NL-16-0415

Joseph M. Farley Nuclear Plant – Units 1 and 2
Response to Request for Additional Information for
TS 3.3.5 Loss of Power Diesel Generator Start Instrumentation LAR

SNC Response to RAIs

Figure 4a

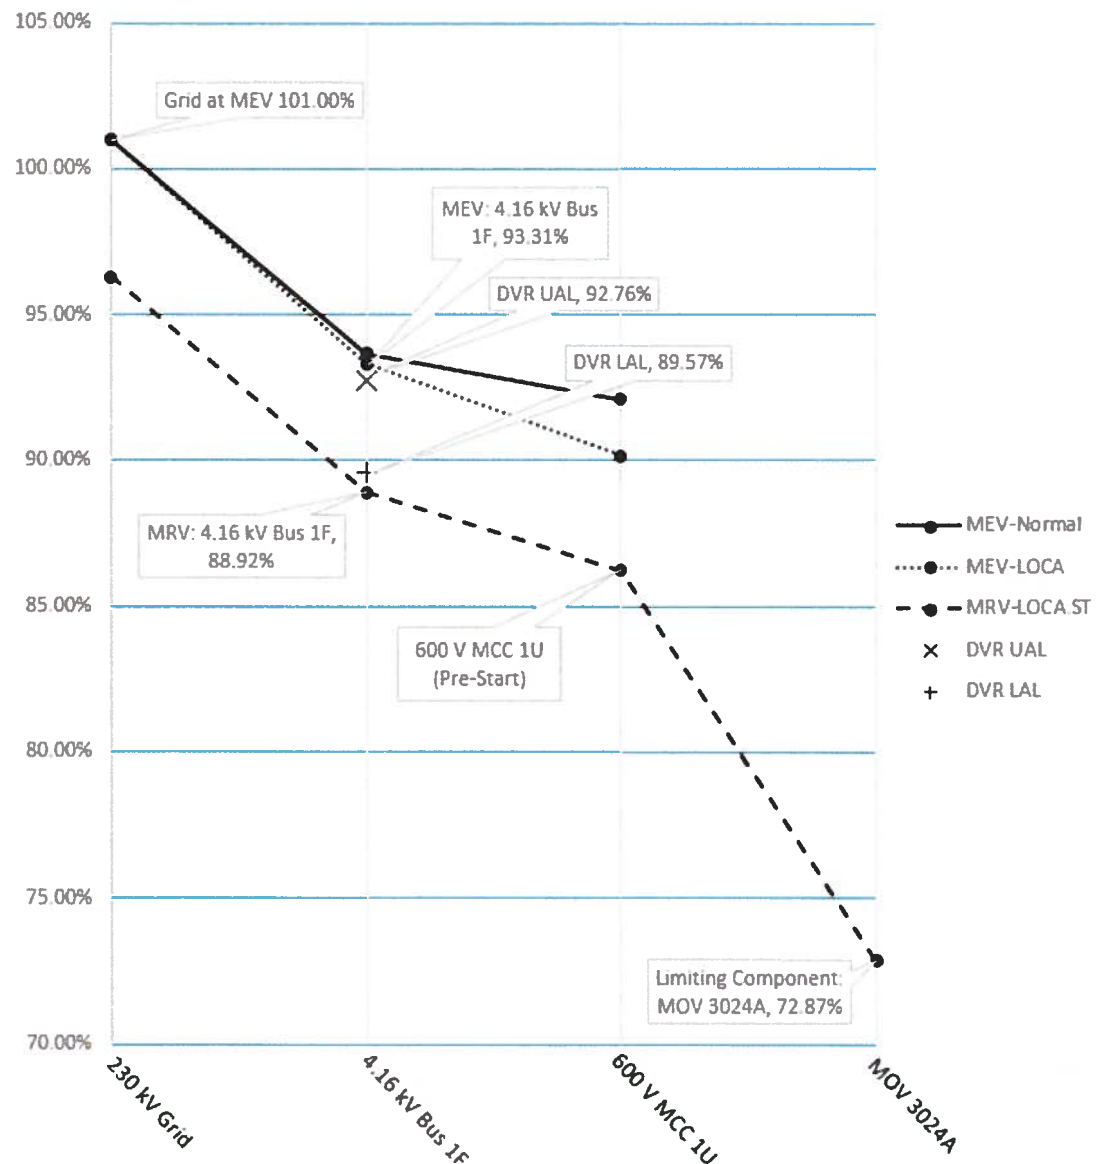
- a. Provide the technical /regulatory basis for not using lower analytical value 3726.11 V in determining the limited components.
- b. Demonstrate that before reaching the DVR lower analytical limit or lower allowable value, including the time delays, all loads can meet their design functions during the worst-case design basis accidents/events without tripping the protective devices such as fuses, breakers, relays (TOLs).
- c. Provide the purpose of non-TS alarm and which actions will be prompted if it is actuated.

See Table 4.a below for an example of how the LAL being above the MRV ensures approximately 0.65% voltage margin at limiting components. The voltage range between the LAL and MRV, referred to as "DVR Margin" in SE-SNC529029-001 and SE-SNC529029-002 Table 1a, diminishes the risk that future plant modifications which add load to the safety-related buses would require updates to the LAL and thereby to the TS 3.3.5 values for the DVRs. An example of the LAL, MRV, and limiting component voltages follows in Figure 4.a below.

Example of voltages at critical buses for normal and LOCA case studies used to determine 4.16 kV Bus 1F MEV, MRV, UAL, and LAL, showing MOV 3024A as the limiting component.

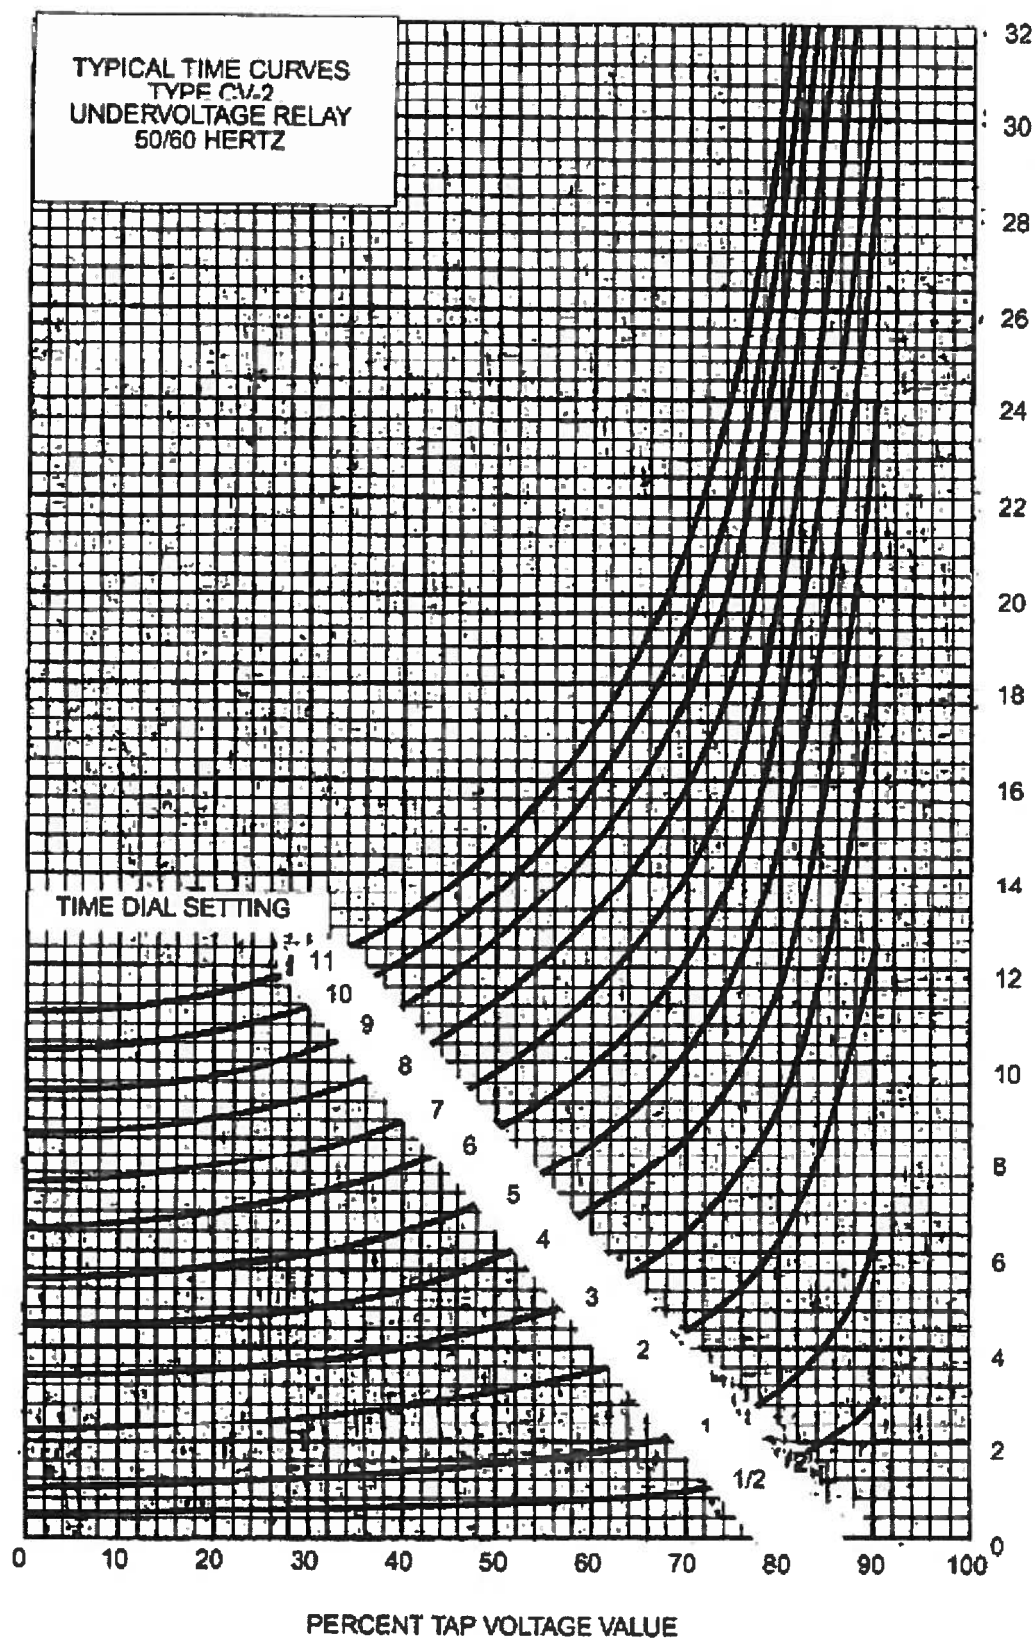
1. Function 1, "4.16 kV Emergency Bus Loss of Voltage DG Start" and Function 2, "4.16 kV Emergency Bus Degraded Grid Voltage Actuation," has the Trip Setpoint column replaced by a new Delay Time column that only displays one time delay. Please explain how: a) FNP is complying with PSB-1 in regards to the use of two time delays, and b) provide technical and regulatory bases for deleting the trip setpoint column from the Technical Specifications.
2. Function 3, "4.16 kV Emergency Bus Degraded Grid Voltage Alarm," is deleted from the TS. Please explain how FNP is complying with PSB-1 in regards to the deletion of the 4.16 kV Emergency Bus Degraded Grid Voltage Alarm from the Technical Specifications.

Note that in the existing protection scheme, the three functions addressed by TS Table 3.3.5-1 are all performed by Type CV-2 induction disc relays. These relays have an inverse-time operating characteristic (the operating curve is provided in Enclosure 2) such that the delay time depends on how much the sensed voltage drops below the actuation setpoint. No allowable values for delay time are specified in the current TS Table 3.3.5-1.

Figure 12. Typical Time Curves Of The Type CV-2 Short Time Undervoltage Relay

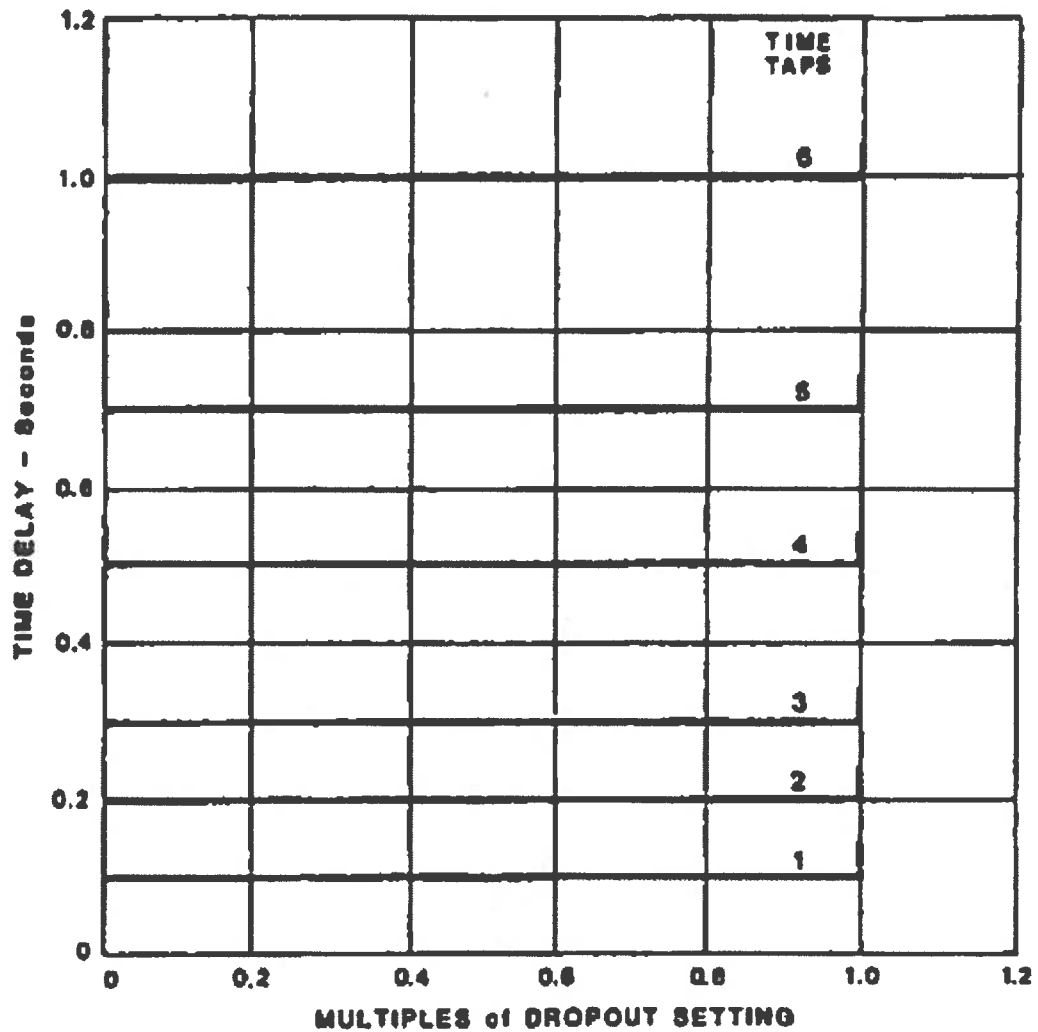
Please explain the basis for not replacing the induction type relays with solid state relays for loss of voltage (LOV) relays. Provide vendor supplied operating curves for the new solid state 27N type relays as well as induction disc relays (currently in use).

Vendor-supplied operating curves are provided for the Type CV-2 and Type 27N relays in Enclosure 2.
